HISTORIC AND DESIGN REVIEW COMMISSION

February 05, 2025

HDRC CASE NO: 2025-015
ADDRESS: 1915 W KINGS HWY
LEGAL DESCRIPTION: NCB 1934 BLK 32 LOT 4 W 21.38 FT OF 3
ZONING: R-6, H
CITY COUNCIL DIST.: 7
DISTRICT: Monticello Park Historic District
APPLICANT: Luis Lopez/One Stop Construction and Cons
OWNER: Daniel Anastasio/ANASTASIO DANIEL
TYPE OF WORK: Garage door and window replacement; fenestration modifications; and exterior painting
APPLICATION RECEIVED: December 12, 2024
60-DAY REVIEW: February 10, 2025
CASE MANAGER: Bryan Morales
REQUEST:

Project: Repair to Existing Accessory Structure for
Daniel Anastacio
1915 W. Kings Hwy., SAN ANTONIO, TEXAS

4 PROPOSED WEST ELEVATION
SCALE: 1/4"=1'-0"

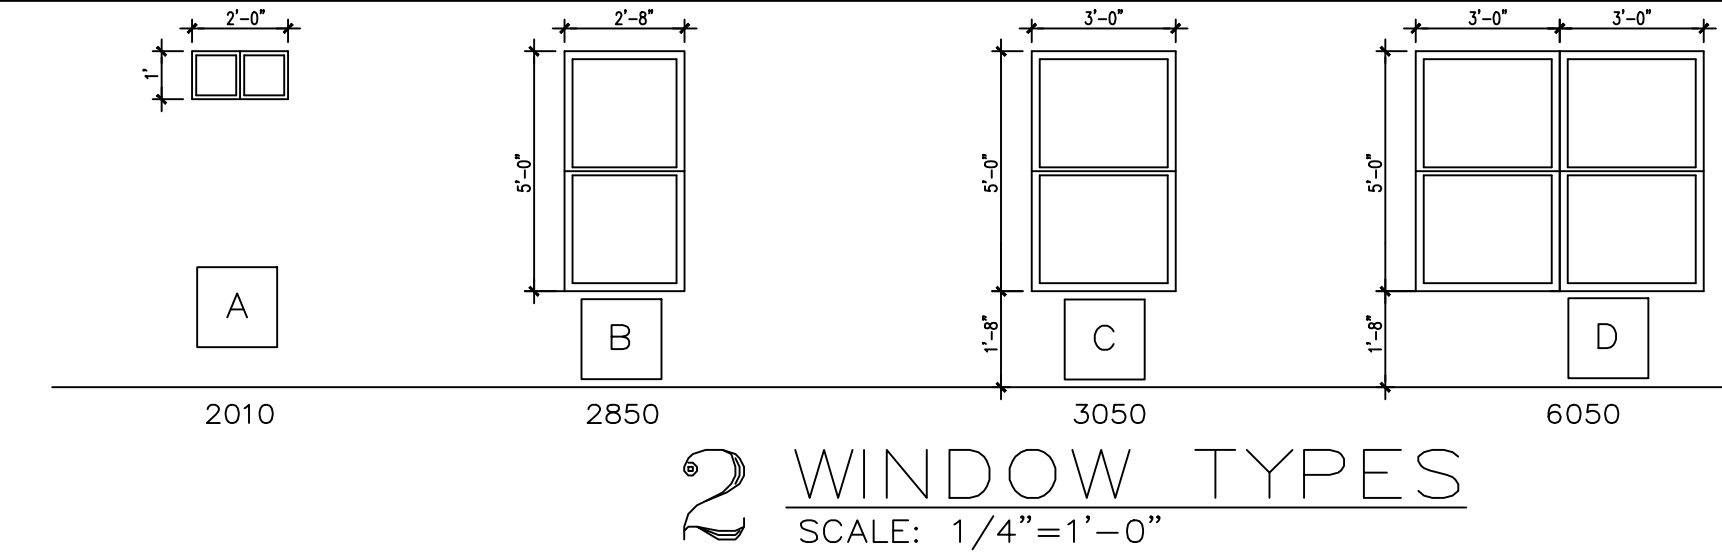
- f. FENESTRATION MODIFICATIONS – The applicant is requesting approval to install a pair of ganged 3x5' windows and one 1x2' window on the west façade. The applicant has indicated the proposed ganged windows will match the currently installed vinyl windows onsite featuring faux internal muntins. Additionally, the proposed 1x2' window will be a horizontal sliding window. The applicant has not provided a cutsheet or technical document for the proposed windows. Exterior Maintenance and Alterations 6.B.iv. states to install new windows to match the historic or existing windows in terms of size, type, configuration, material, form, appearance, and detail. While staff finds the addition of new window openings on the existing detached garage generally appropriate, staff finds the proposed windows and window designs do not conform to Guidelines. Staff recommends the applicant modify their request to include the new window openings featuring historically appropriate sizes, types, configurations, materials, form, appearance, and detail.

Item 3: Staff recommends approval for the window installation on the west façade, based on findings a and f, with the following stipulation:

- i. That the applicant installs a fully wood or salvaged wood window that meet staff's standard window stipulations and submits updated specifications to staff for review and approval. The windows should feature an inset of two (2) inches within facades and should feature profiles that are found historically within the immediate vicinity. Meeting rails must be no taller than 1.25" and stiles no wider than 2.25". White manufacturer's color is not allowed, and color selection must be presented to staff. There should be a minimum of two inches in depth between the front face of the window trim and the front face of the top window sash. This must be accomplished by recessing the window sufficiently within the opening or with the installation of additional window trim to add thickness. Window trim must feature traditional dimensions and architecturally appropriate sill detail. Window track components must be painted to match the window trim or concealed by a wood window screen set within the opening.

5 PROPOSED SOUTH ELEVATION
SCALE: 1/4"=1'-0"

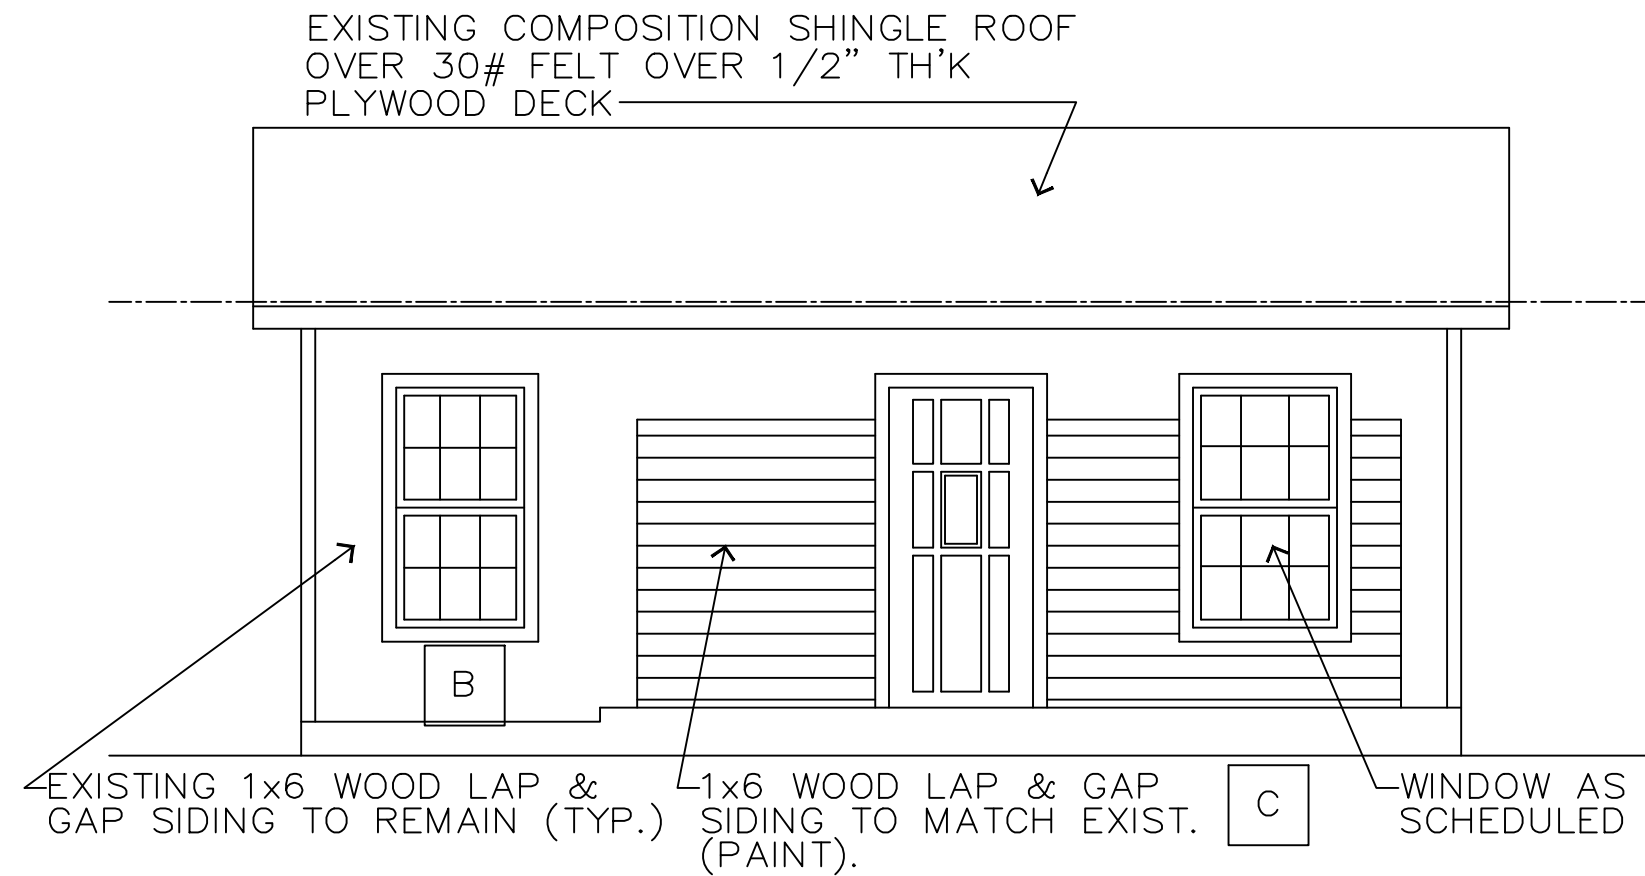
- d. GARAGE DOOR INFILL – The applicant is requesting approval to infill the existing garage door on the detached garage and install a door, vinyl window featuring internal faux muntins, and in-kind siding. The Historic Design Guidelines for Exterior Maintenance and Alterations 6.A.i. states to preserve existing window and door openings and to avoid creating new primary entrances or window openings on the primary façade or where visible from the public right-of-way. Staff finds the infill of the existing garage door generally appropriate.

Item 1: Staff recommends approval for the garage door infill, based on findings a through d, with the following stipulations:

- i. That the applicant installs a fully wood or salvaged wood window that meet staff's standard window stipulations and submits updated specifications to staff for review and approval. The windows should feature an inset of two (2) inches within facades and should feature profiles that are found historically within the immediate vicinity. Meeting rails must be no taller than 1.25" and stiles no wider than 2.25". White manufacturer's color is not allowed, and color selection must be presented to staff. There should be a minimum of two inches in depth between the front face of the window trim and the front face of the top window sash. This must be accomplished by recessing the window sufficiently within the opening or with the installation of additional window trim to add thickness. Window trim must feature traditional dimensions and architecturally appropriate sill detail. Window track components must be painted to match the window trim or concealed by a wood window screen set within the opening.

- ii. That the applicant provide staff with updated construction documents showing the installation of in-kind siding versus the proposed lap-and-gap siding.

- iii. That the applicant incorporate window trim to allow the installation of wood window screens if desired.
- iv. That the applicant install an architecturally appropriate door and provide final door specifications to OHP staff for review prior to the issuance of a Certificate of Appropriateness.
